# CH2M HILL ENGINEERING CHANGE NOTICE

1a. ECN 725832 R 1

**18. Description of the Change** (Use ECN Continuation pages as needed)  
 ECN-725832-R1 supercedes ECN-725832-R0 in its entirety.  
**PROBLEM STATEMENT:** Catch tank 240-S-302 contains approximately 8,000 gallons of waste. Approximately 7,000 gallons of liquid sits on top of a solids inventory of 1,000 gallons. The catch tank is classified as an inactive miscellaneous underground storage tank. The removal of the free liquid from this leaking catch tank is a priority with the Washington State Department of Ecology. The design and fabrication of the 240-S-302 liquid pumping system is complete. The installation and operation of the system is pending. Flush water is to be used for performing the initial system leak check following installation, and following potential filter assembly replacements. The use of filtered water is desired to minimize the solids loading onto the pumping system filter train from potential debris in the site raw water. A flush filter assembly needs to be fabricated and design media updated to reflect its use. The flush filter assembly is to be fabricated and installed to support the planned operation

Document/Drawing No. H-14-107503 Sheet 1 Revision 0

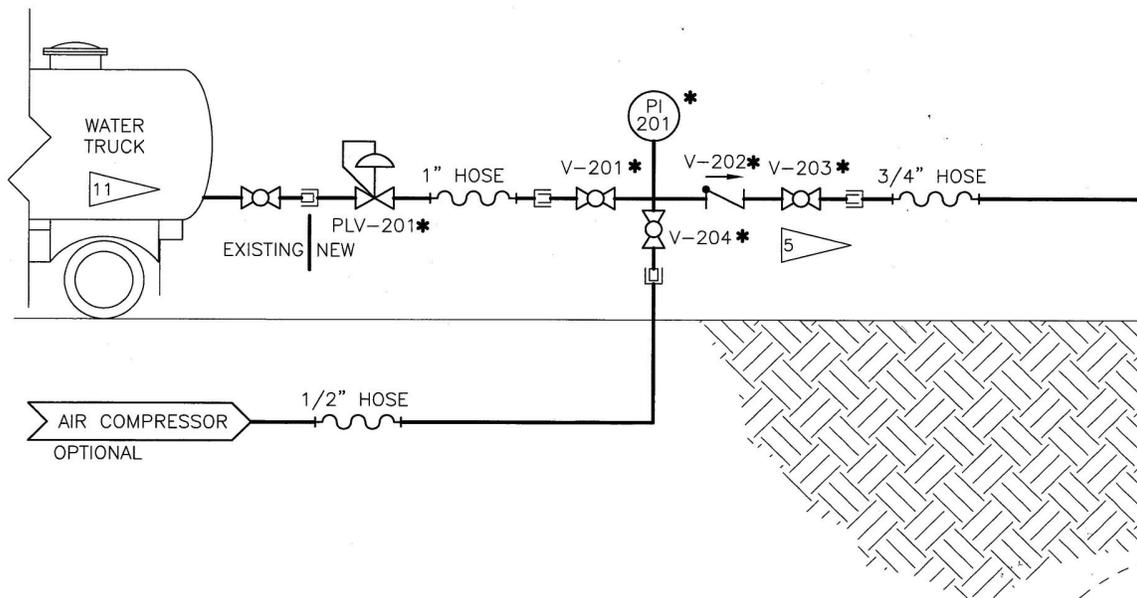
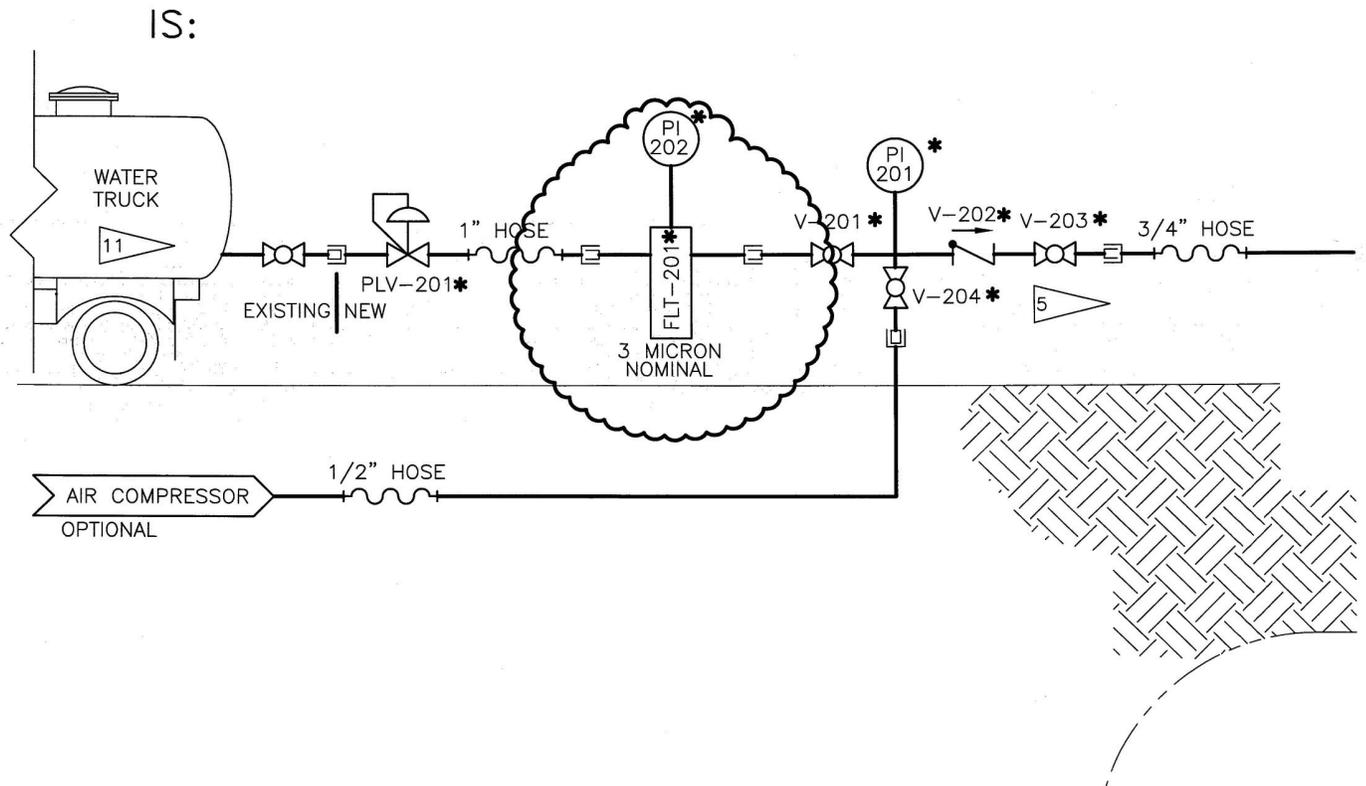
H-14-107503 Sheet 1; Add FLT-201 and PI-202 to the P&ID in the area of flush manifold, change as shown on page 5.

Document/Drawing No. H-14-107508 Sheet 1 Revision 0

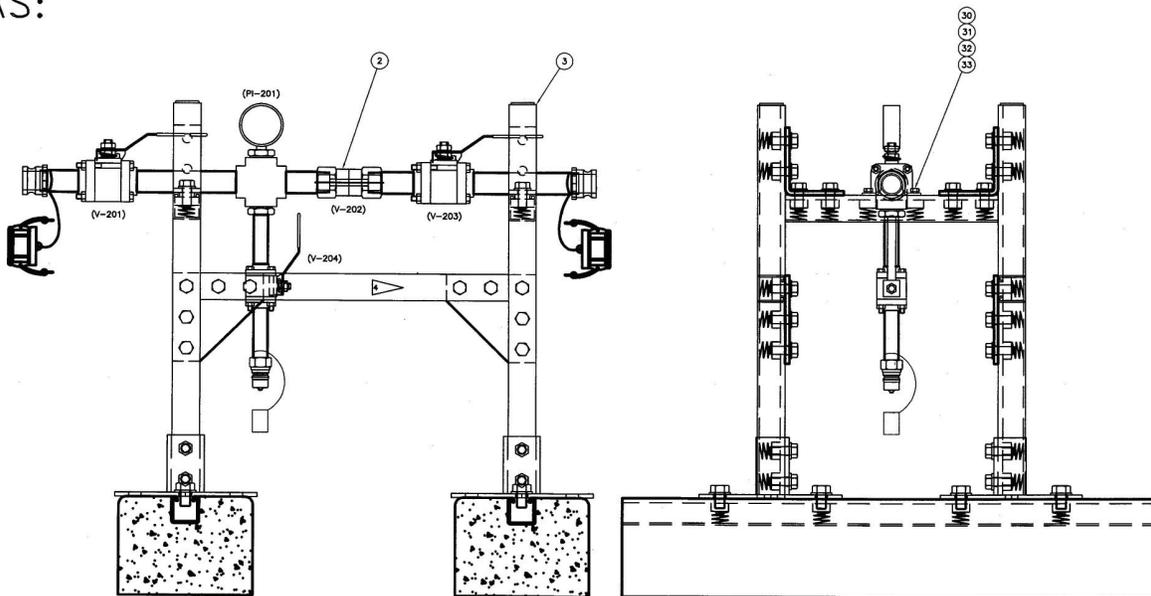
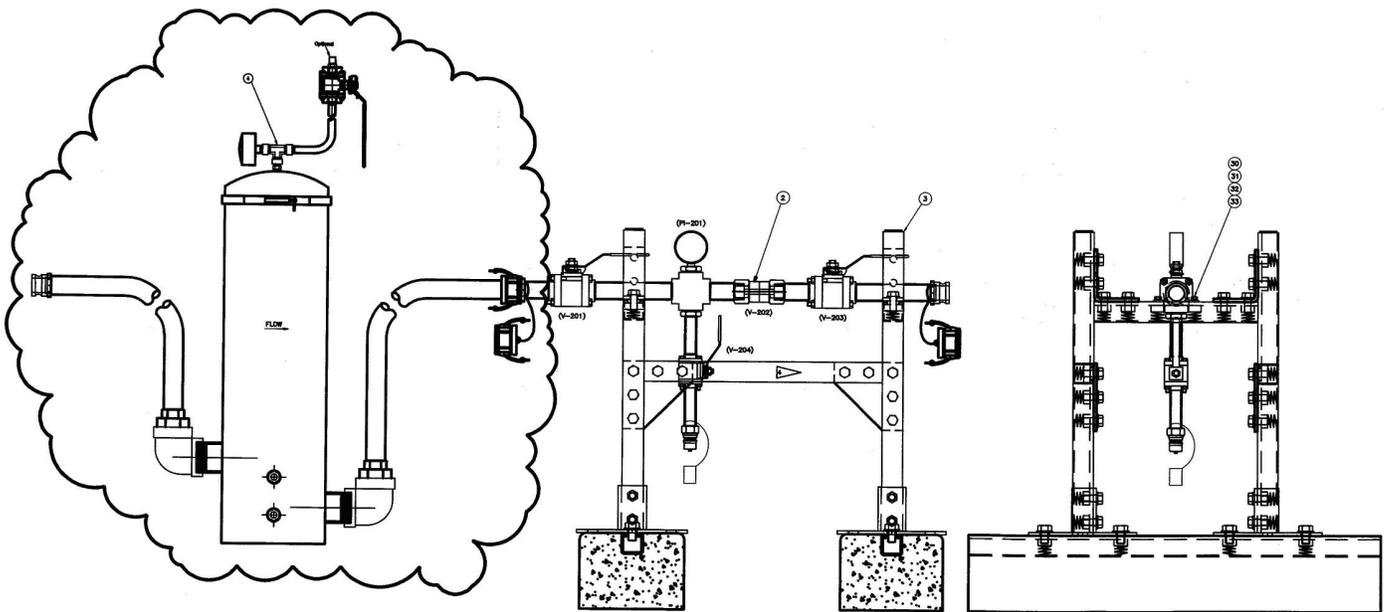
H-14-107508 Sheet 1; Add details for item -040 Flush Filter Assembly, update view of Item 1 – Flush Manifold Assembly to include Flush Filter Assembly, increase quantity of item 14 and add items 38 through 50, add filter and pressure indicator label EIN's to note 8; changes as shown on pages 7 and 9.

IS: ADD NEW LABEL TO NOTE 7, ADD NEW ASSEMBLY ITEM 4 & PARTS ITEMS 38 THRU 50,  
ADD ONE MORE TO THE QTY OF ITEM 14, AS SHOWN IN THE CLOUDED AREAS BELOW.

① FLUSH MANIFOLD ASSEMBLY  
NOTE: FLUSH FILTER ASSEMBLY REMOVED FROM DND VIEW FOR CLARITY.

Document/Drawing No. H-14-107508 Sheet 2 Revision 0

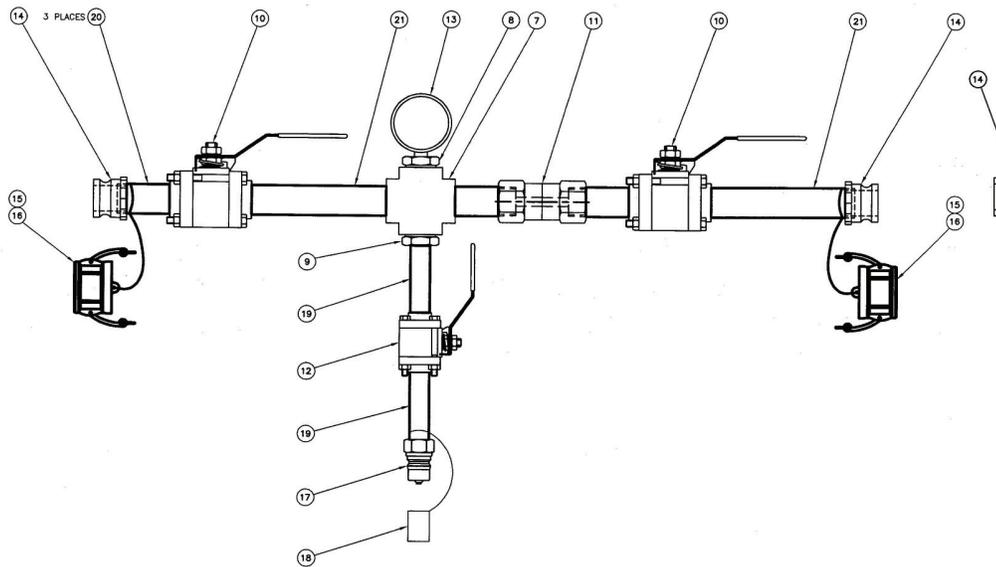
H-14-107508 Sheet 2; Add details for Item 4 - Flush Filter Assembly and associated part identification; changes as shown on page 11.
